C2M EYE-MASK FIGURE 120E-13 UPDATE PROPOSAL

COMMENT # 26

IEEE P802.3bs, IEEE Plenary Meeting
November 2016, San Antonio, Tx

Text SC 120E.4.2 and Figure 120E-13 Correlation

Figure 120E-13—PAM4 eye measurements

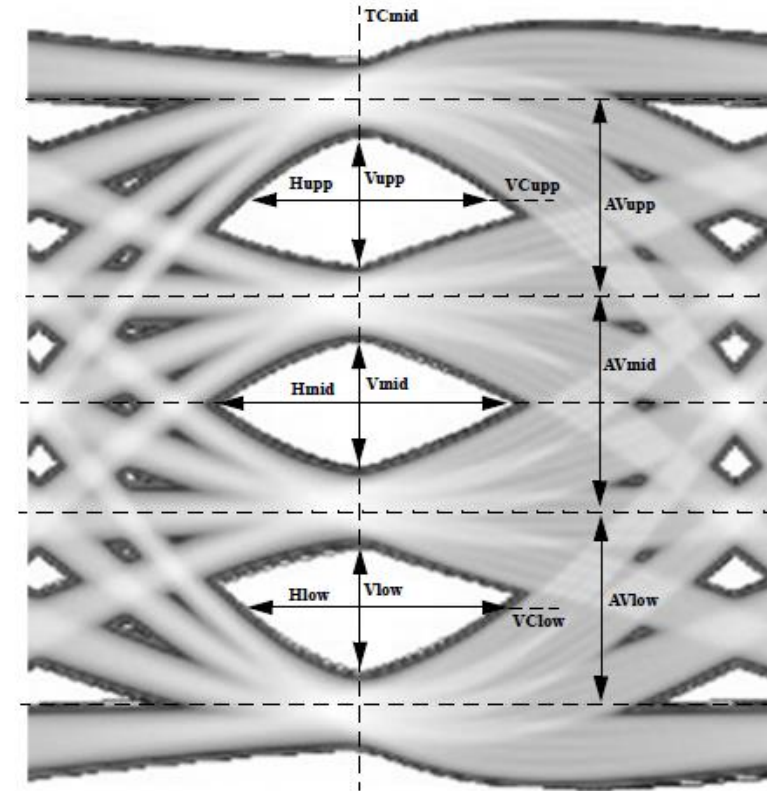
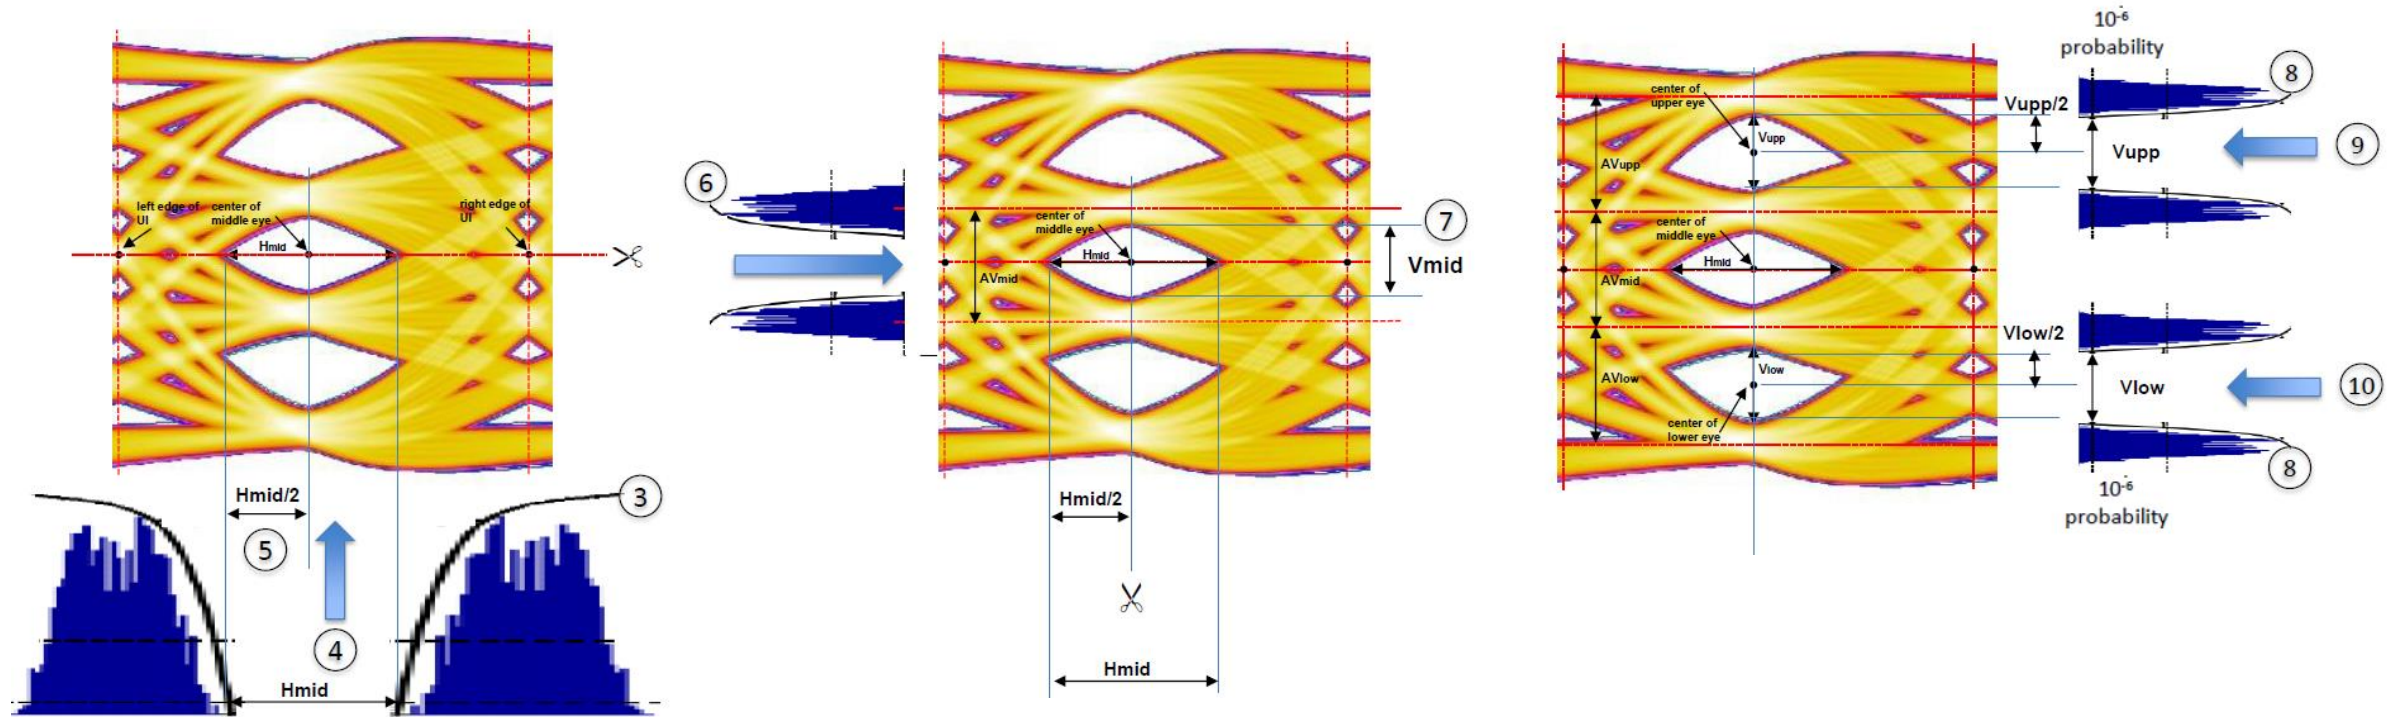
“Section 120E.4.2 Eye Width and Eye Height Measurement Method” includes terminology that it is not reflected in the corresponding Figure 120E-13 and vice versa.

1. +1/3 (MIDCDF1) and -1/3 MIDCDF0 are mentioned in text but there is no reference in corresponding figure.
2. MIDCDF0, MIDCDF1, LOWCDF0, LOWCDF1, UPPCDF0, UPPCDF1 are mentioned in text but there is no reference in corresponding figure.
3. VCmid is mentioned in text but there is no reference in corresponding figure.
4. MIDOCDFL, MIDOCDFR are mentioned in text but there is no reference in corresponding figure.
5. Since VEC equation was deleted per comment #173 against draft Rev 2.0, remove from subject figure the references Avupp, Avmid, Avlow.

Proposed Edits to Figure 120E-13

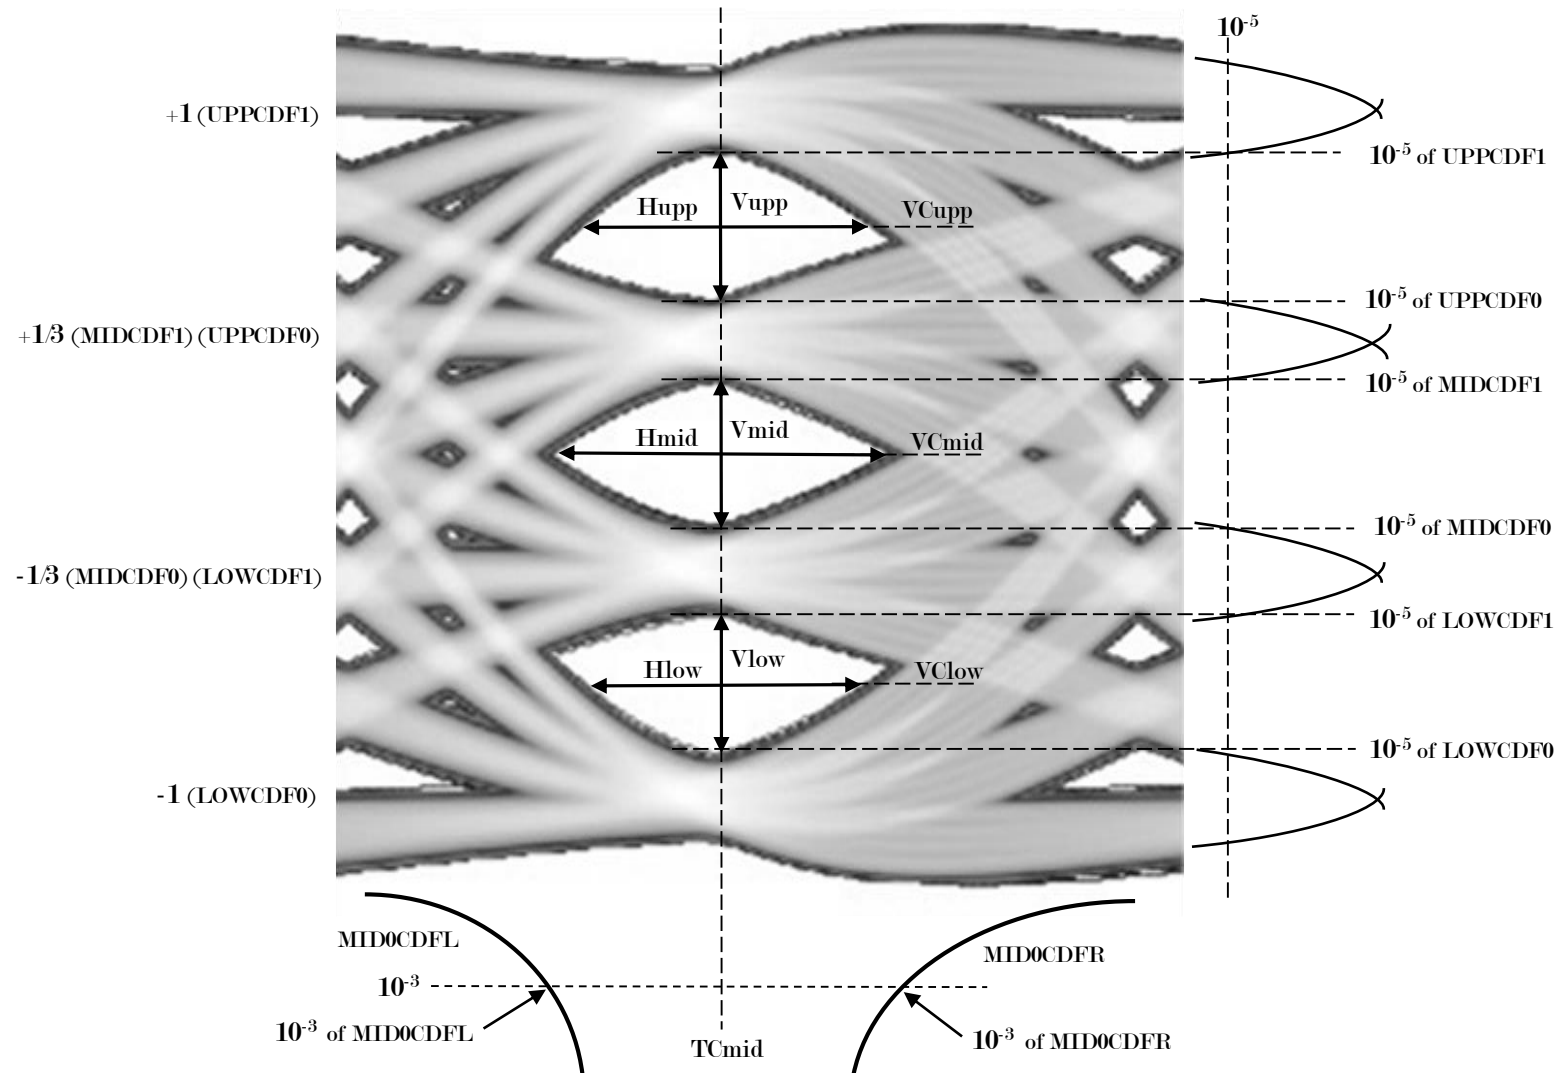
At a minimum propose the following edits to Figure 120E-13:

1. MIDCDF0, MIDCDF1, LOWCDF0, LOWCDF1, UPPCDF0, UPPCDF1 are mentioned in text but there is no reference in corresponding figure.

2. VCmid is mentioned in text but there is no reference in corresponding figure.

3. MIDOCDFL, MIDOCDFR are mentioned in text but there is no reference in corresponding figure.

4. Since VEC equation was deleted per comment #173 against draft Rev 2.0, remove from subject figure the references Avupp, Avmid, Avlow.

Solution: Add MIDCDF0, MIDCDF1, LOWCDF0, LOWCDF1, UPPCDF0, UPPCDF1 to Figure 120E-13

Solution: Add VCmid to Figure 120E-13

Solution: Add MIDOCDFL, MIDOCDFR to Figure 120E-13
